**RECREATIONAL VEHICLE
SAFETY RECALL NOTICE**

Safety Recall: 23V-822

January 16, 2026

IMPORTANT SAFETY RECALL – 5th Notice

Figure 1

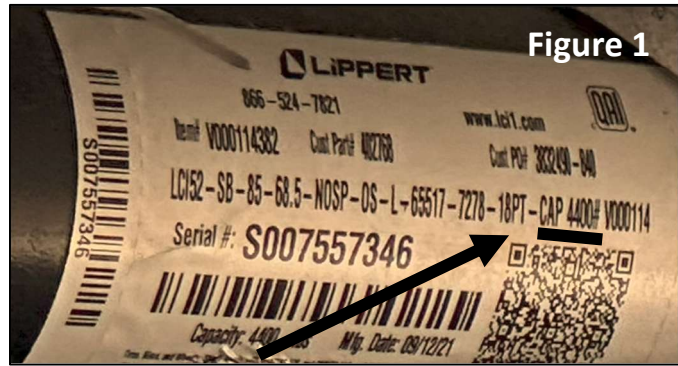
It has been decided that the vehicles in the recall population may have axle springs rated at 4400 pounds rather than the 5100 pound axle rating as specified on Federal Identification Tag. The axles installed had the wrong size springs. Under certain conditions during travel, undersized axle springs can be overloaded leading to an increased risk of axle spring failure and increasing the risk of a crash.

You may choose to self-inspect the axle's tags. If the tag reads as CAP 4400#, as shown in Figure 1, as soon as possible, please make an appointment to have your RV serviced by your dealership. Customers should unload all cargo and empty holding tanks (fresh water, grey water, black water, and water heater) and take their unit to an authorized dealer for remedy of the incorrectly installed axles springs. The labor

Keystone representatives have been in contact with the staff at your selling dealership regarding this situation. The remedy is to replace under rated 4400 LB springs with the correct size 5100 LB springs. This would require both 2200 LB springs be replaced. The service and parts required for this corrective action will be provided at no charge to you.
